MONTGOMERY COLLEGE - OFFICE OF PROCUREMENT
MACKLIN TOWER MBI FINANCE LAB SUITE 100, ROCKVILLE CAMPUS
RFP NO.: 620-011
RFP CLOSING DATE AND TIME: APRIL 7, 2020 @ 3:00 PM

ADDENDUM #1
Issued: March 27, 2020

Project:	MC RV MT MBI FINANCE LAB SUITE 100 RENOVATIONS	Date:	03/25/2020
		Reference:	
Title:	Addendum #1 Drawing Narrative	BKM Project No:	19106.01

SHEET TITLE: FIRST FLOOR PLAN PLUMBING NEW WORK

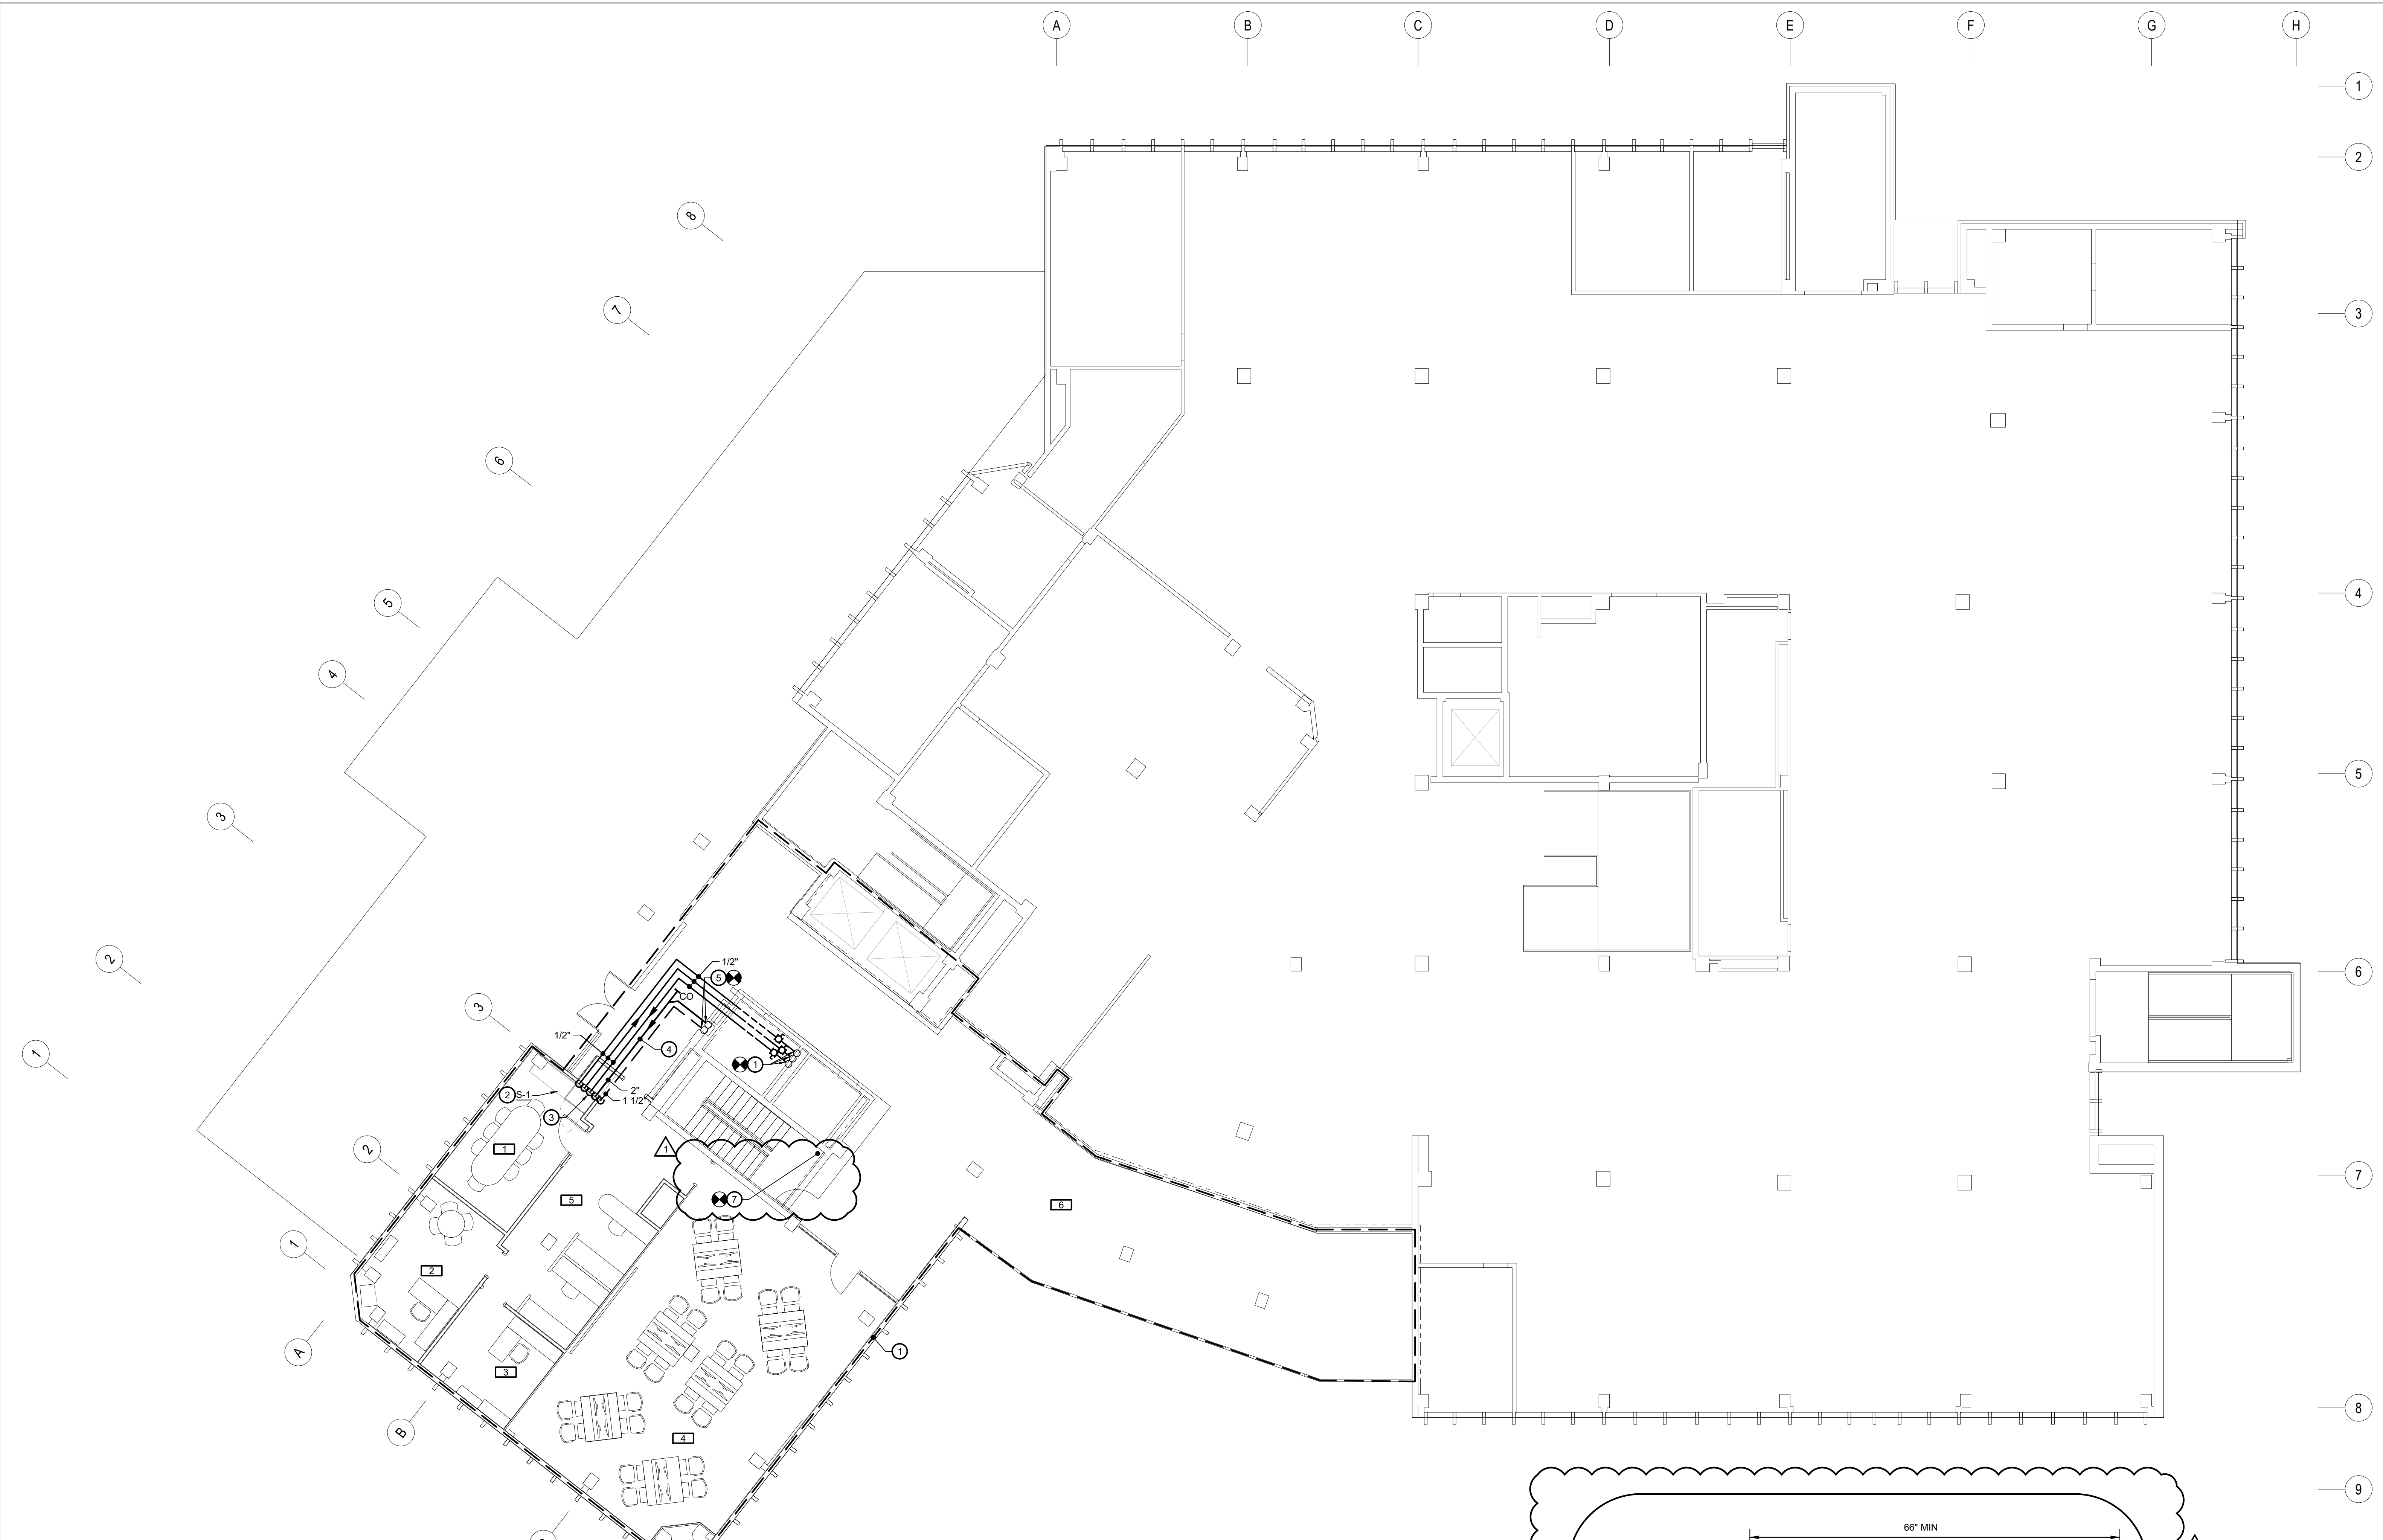
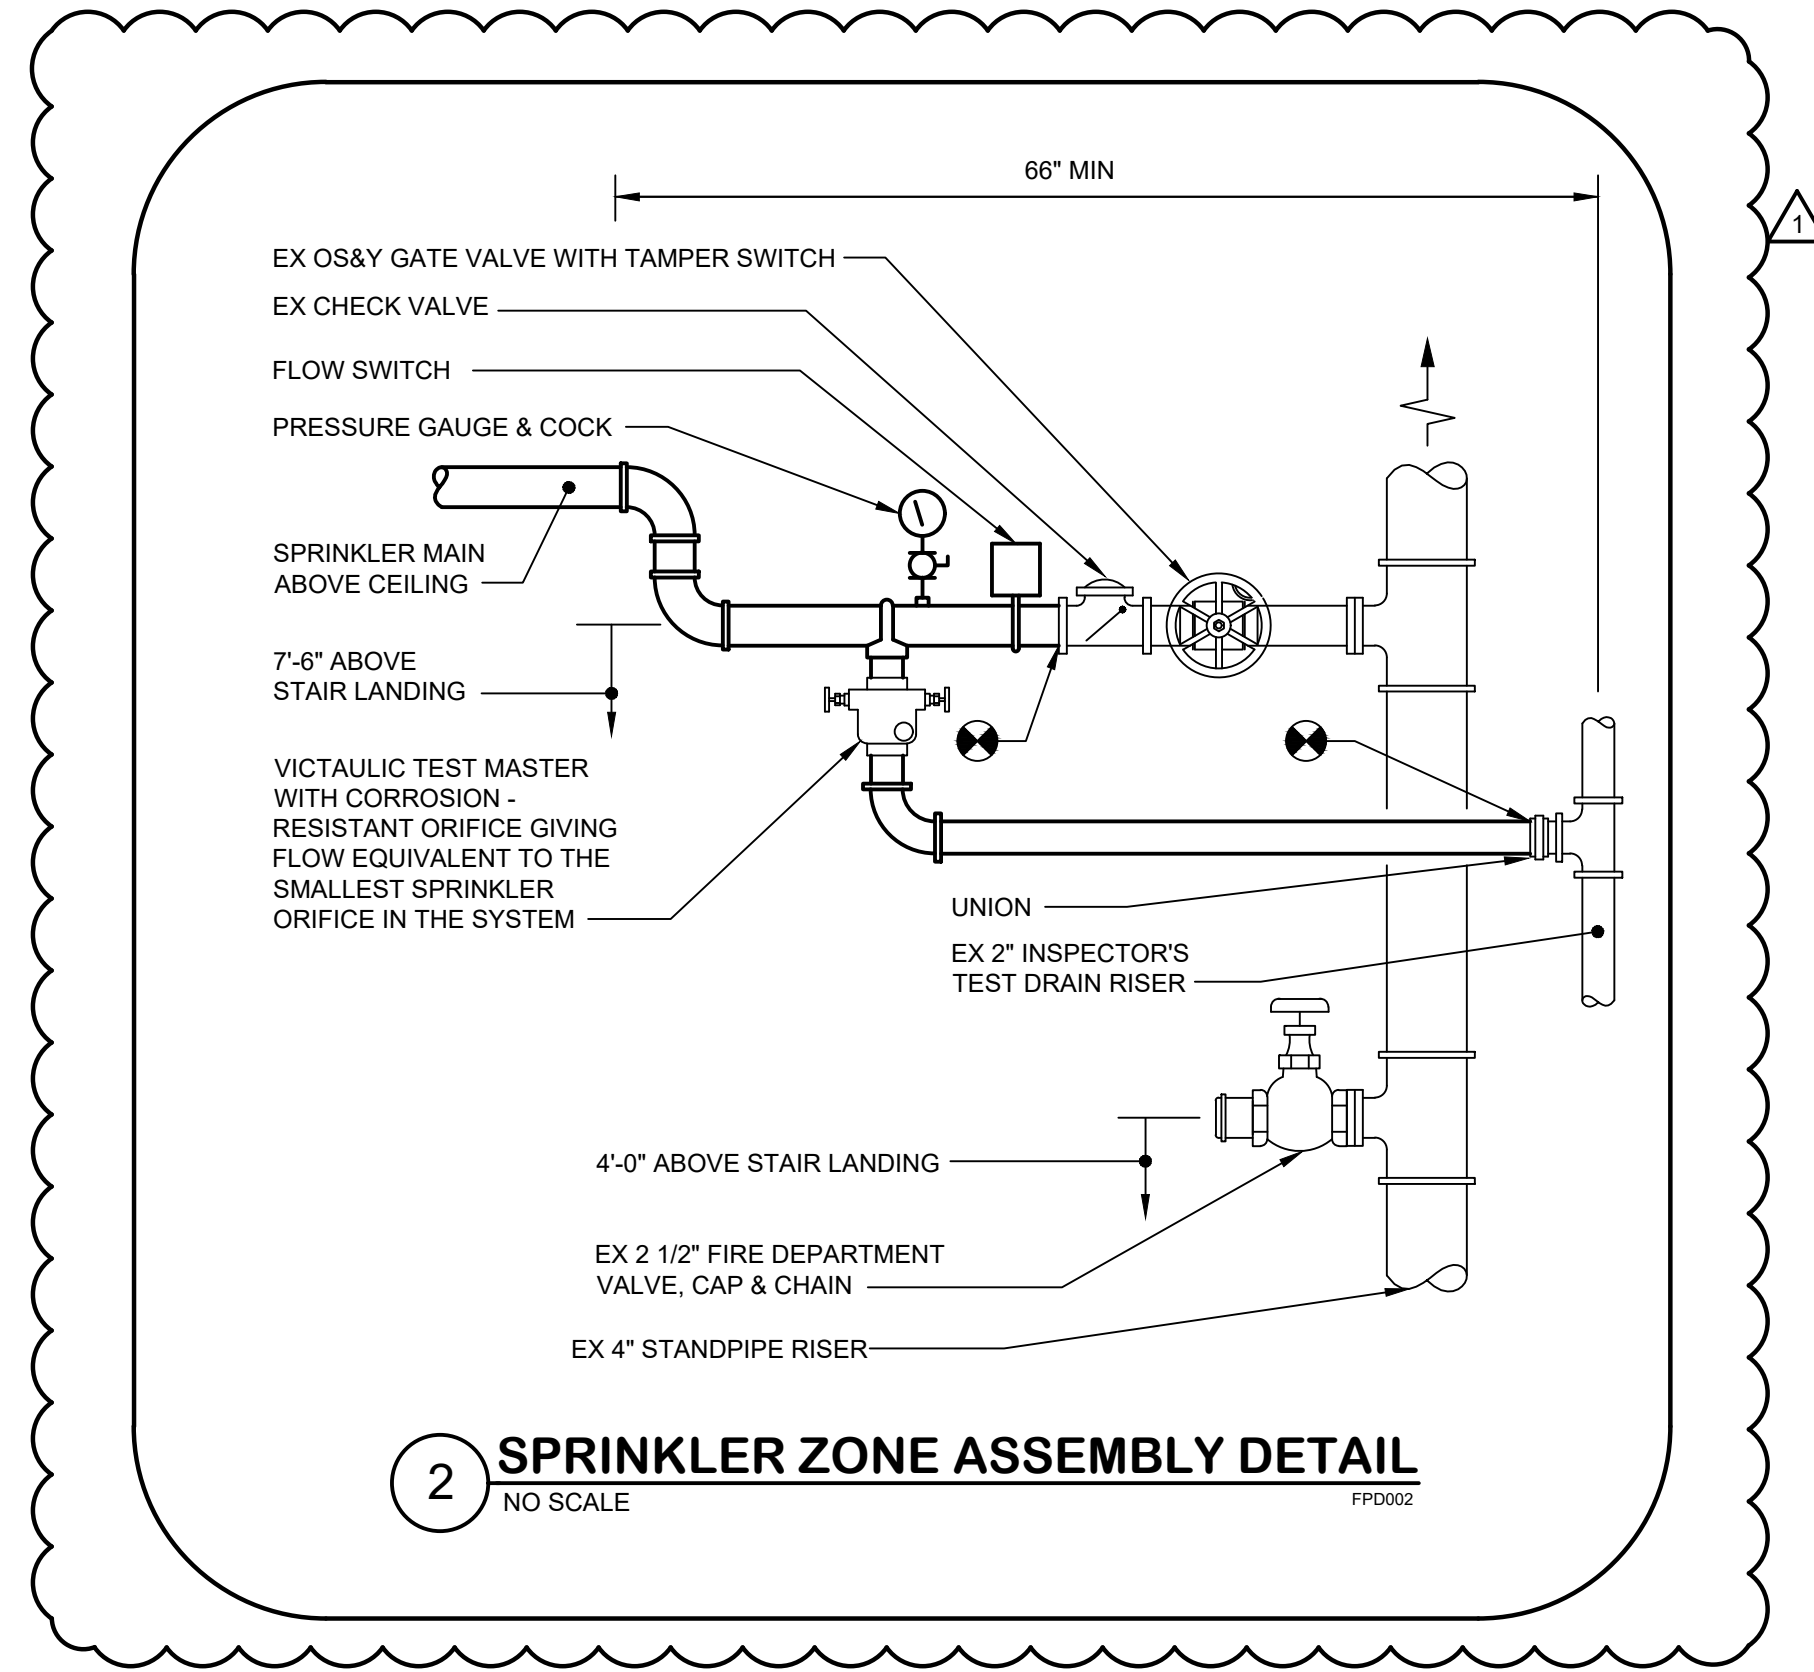
P2.01 “First Floor Plan – Plumbing – New Work”

- Sprinkler Piping has been added throughout the project area.
- “Sprinkler Zone Assembly” detail has been added to show requirements for connection to existing standpipe.

- EXTEND NEW SPRINKLER PIPING FROM EXISTING 4" STAND PIPE RISER. INSTALL SPRINKLER SYSTEM IN ACCORDANCE WITH NFPA 13. PROVIDE FLOW SWITCH, PRESSURE GAUGE AND VICTAULIC TEST MASTER EXTENDED TO EXISTING 2" INSPECTOR'S TEST DRAIN RISER.

SHEET TITLE: FIRST FLOOR PLAN - POWER & SPECIAL SYSTEMS - NEW WORK

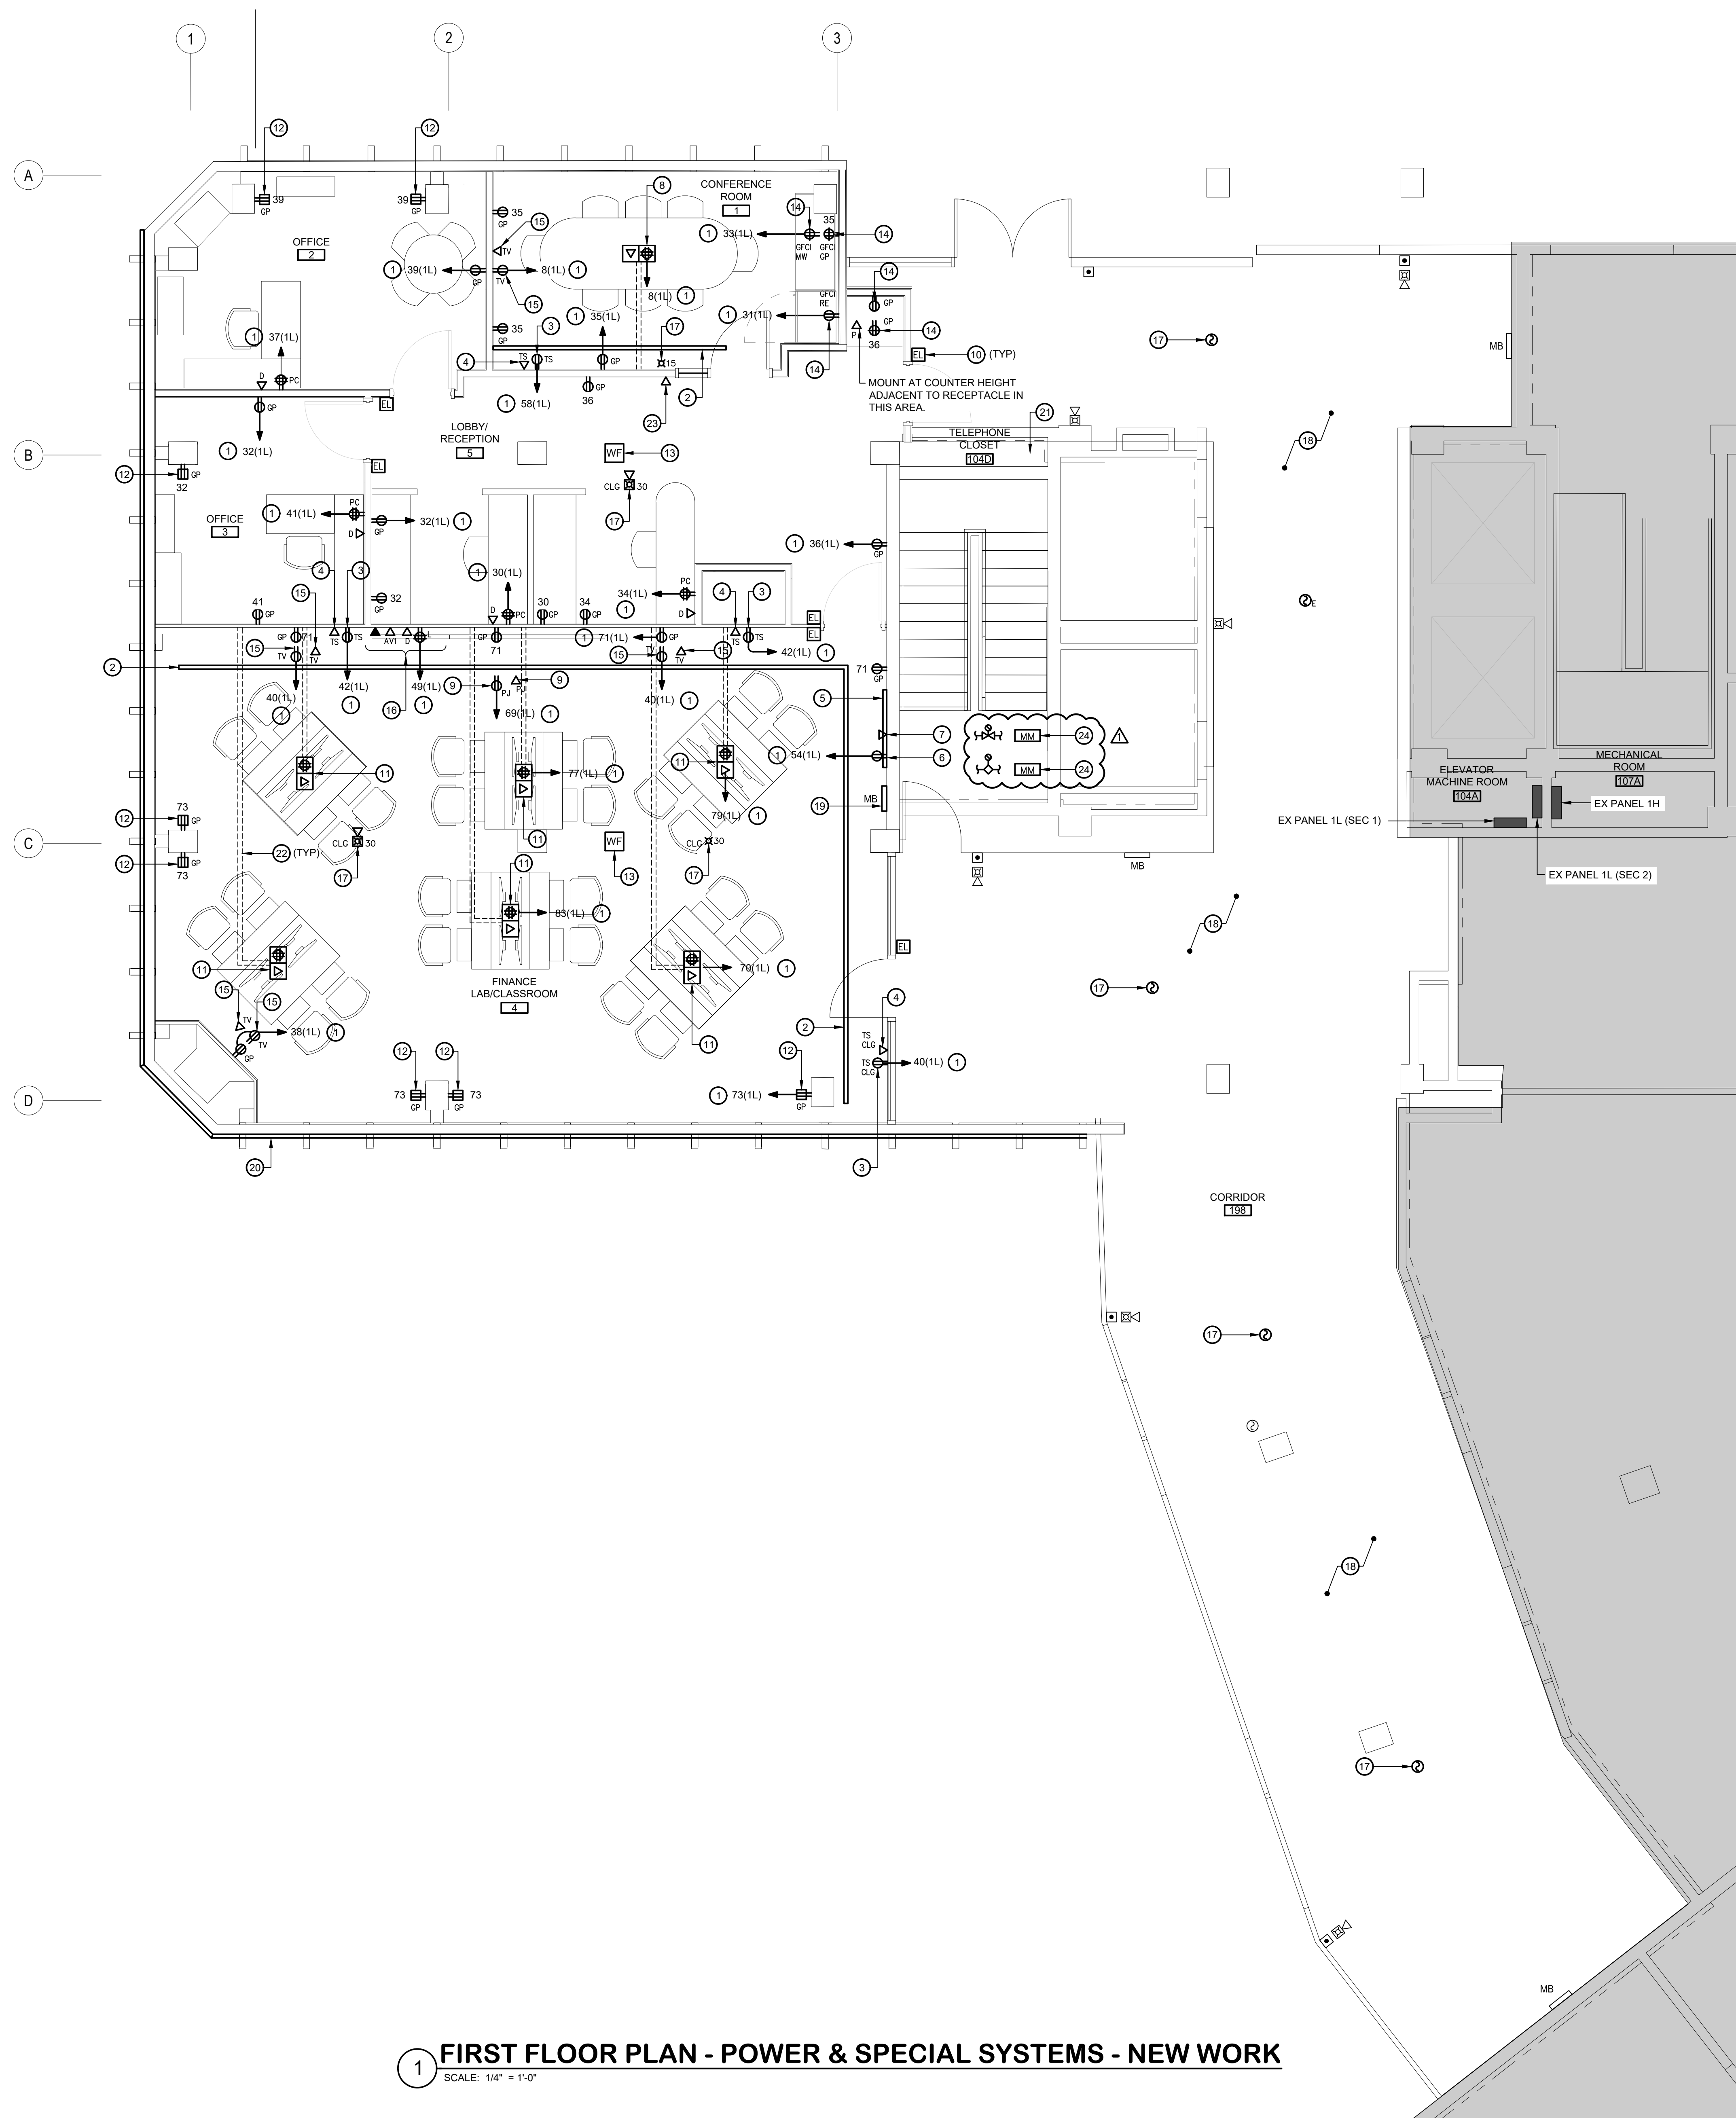
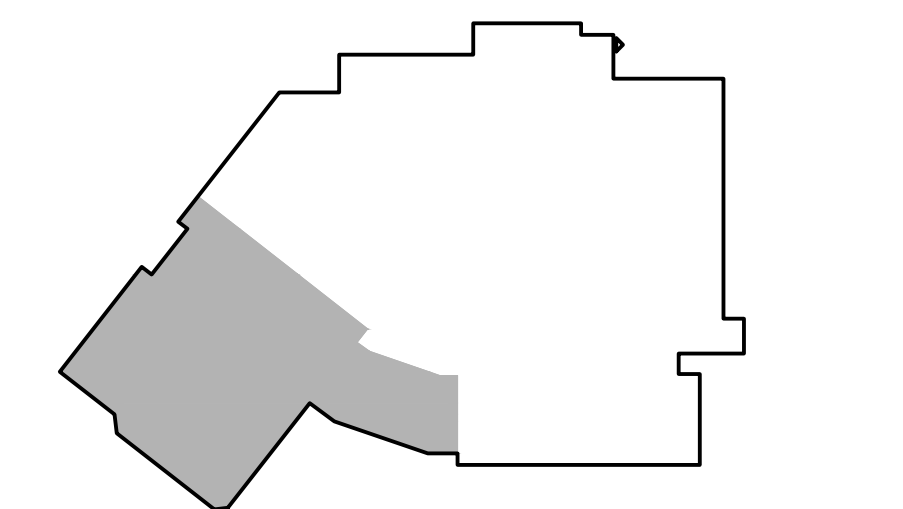
Item 2-7 Question: Refer to Specification Section 087100 Door Hardware, Page 14. Set #3 – shows one HID Reader. Based on lock Specification ML20932 x SEC and Drawing E2.01, it assumed this door requires both Entry and Exit Readers. Please Clarify.

E2.01 “First Floor Plan – Power & Special Systems – New Work”

- Note 24 has been added to provide monitor module for sprinkler flow/tamper switch.

Answer: Yes, this hardware set should have had 2 readers on it.

- PROVIDE MONITOR MODULE FOR SPRINKLER FLOW/TAMPER SWITCH.
